project Intermountain Alta View Hospital Acute project no 19740.00

Rehab Unit

date 2021-01-21 no. pages

End of Addendum 003

ED101A

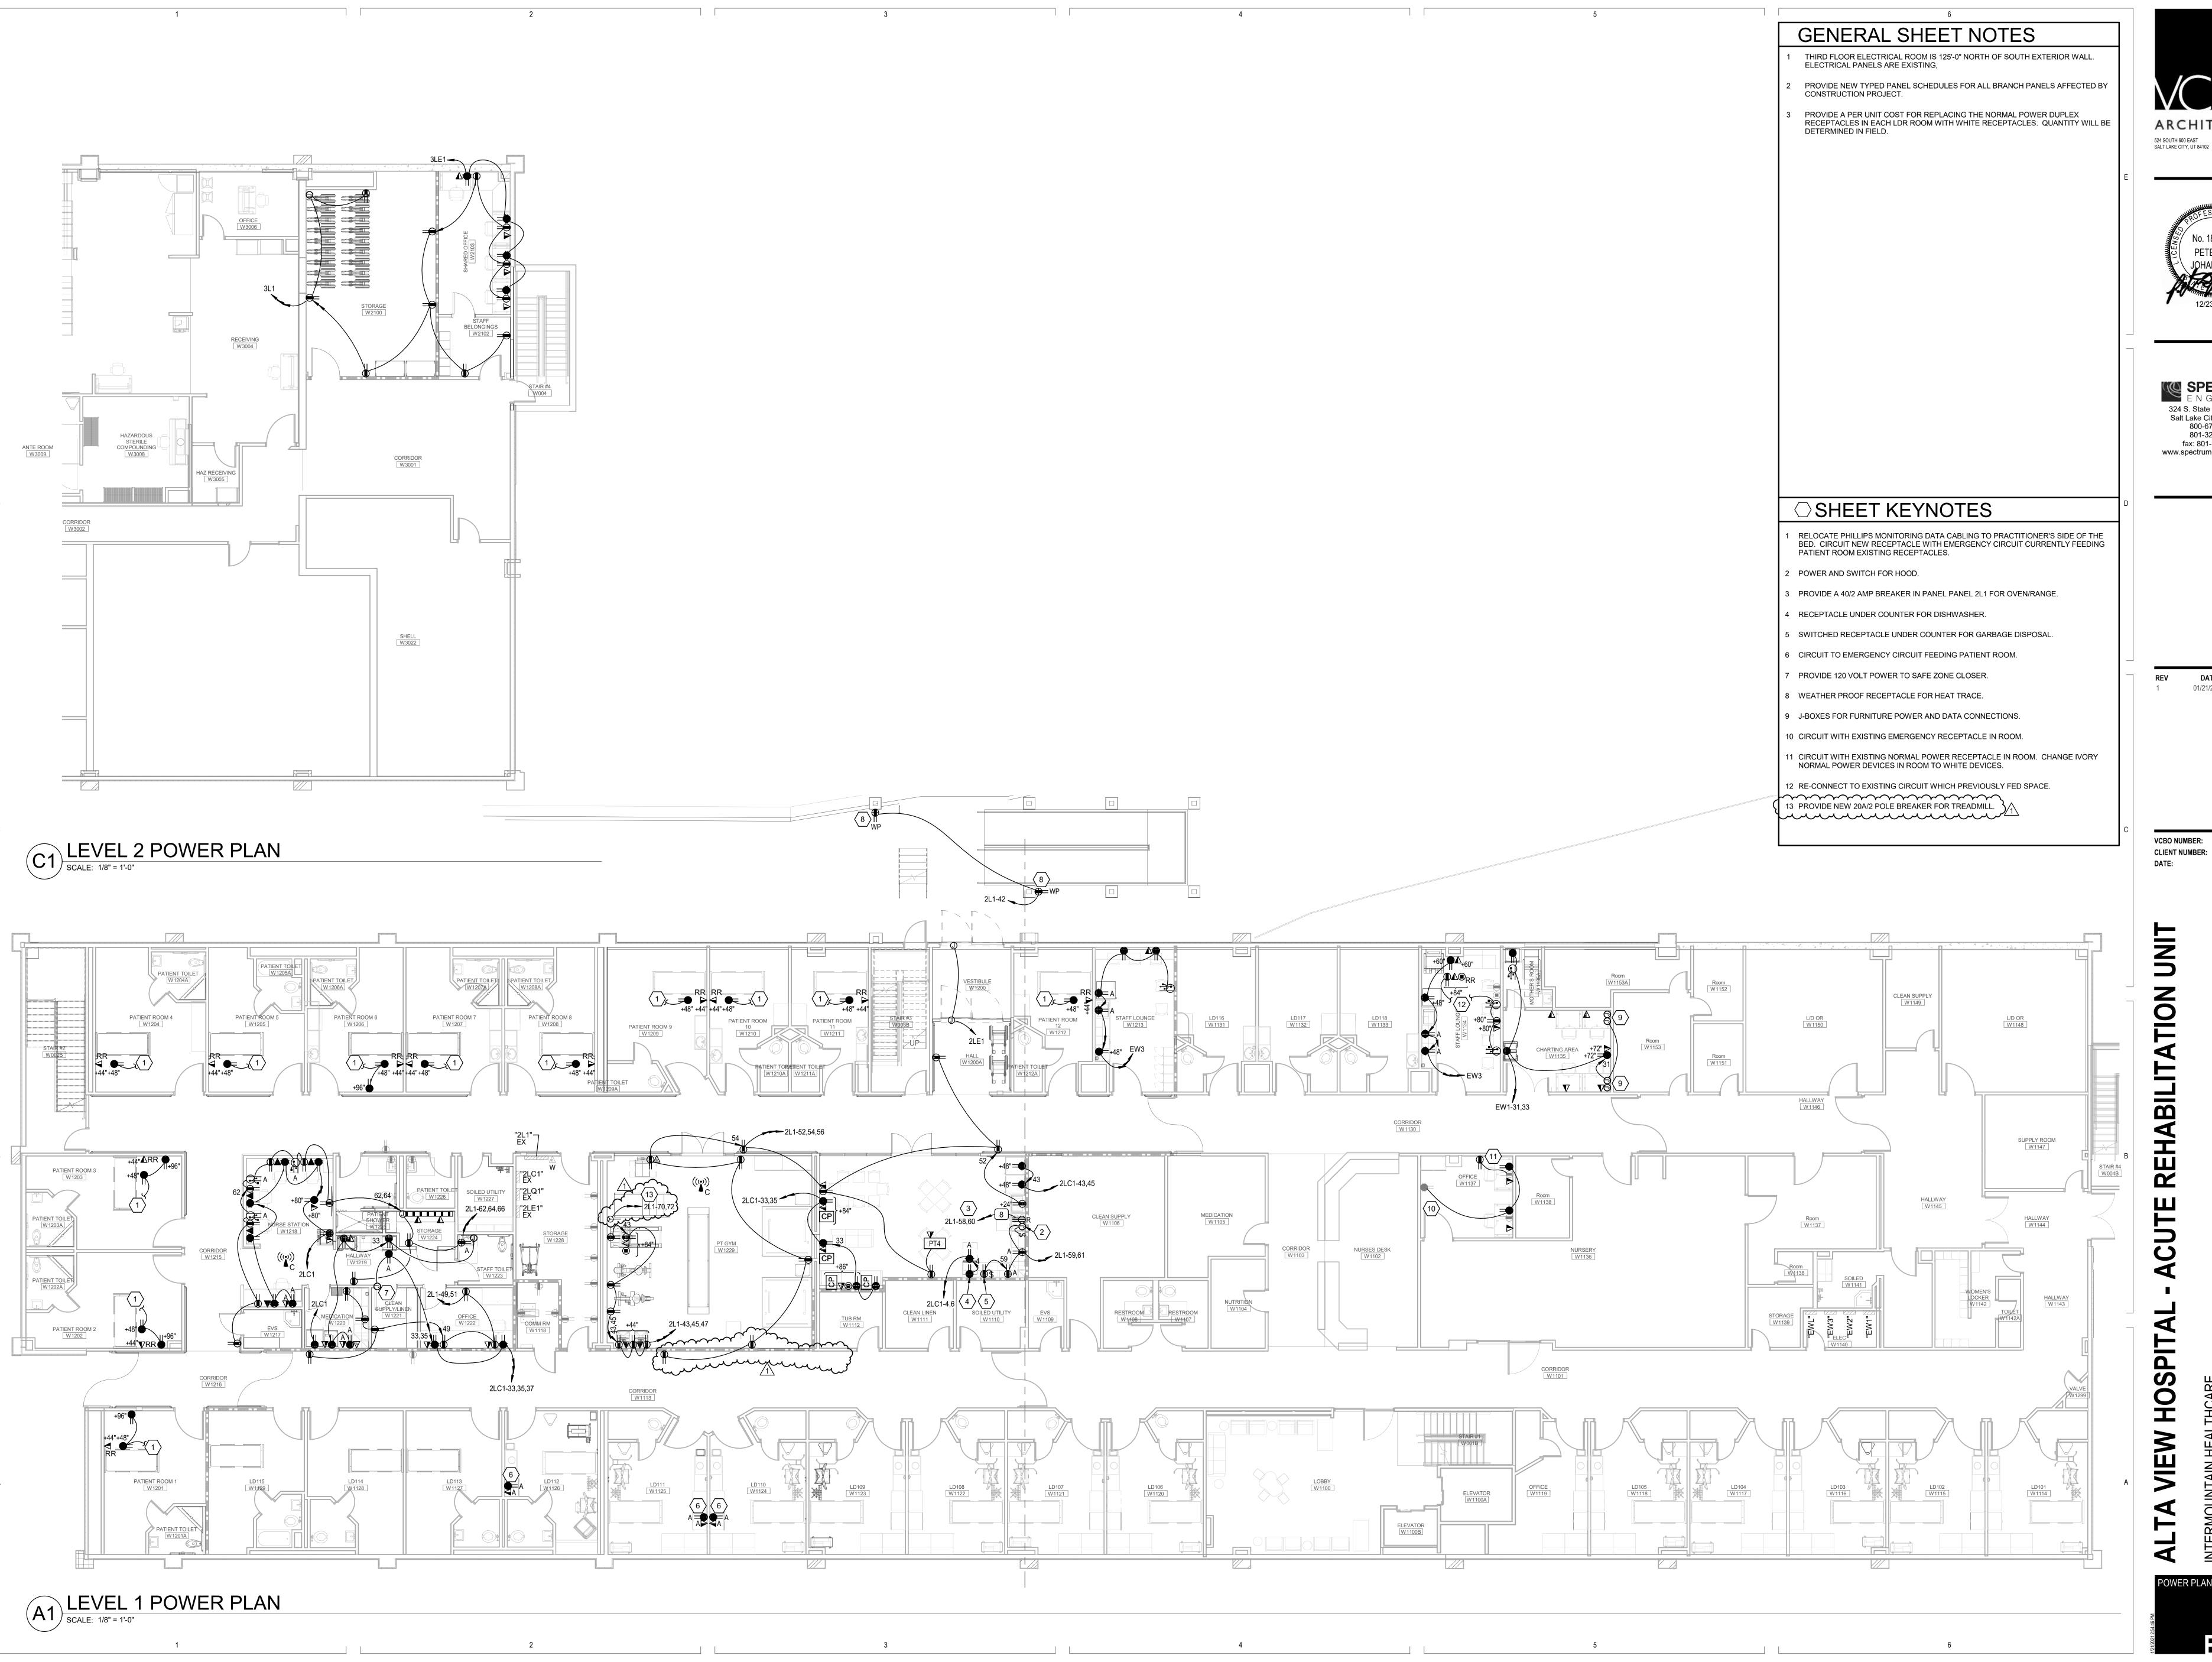
- 1. ED101A Power demolition
 - a. Relocated key pad along with relocated northwest double doors
- 2. EP101 Power Plan
 - a. Added 208/1 volt circuiting for treadmill
 - b. Circuited hallway receptacle
- 3. EL601 Fixture schedule
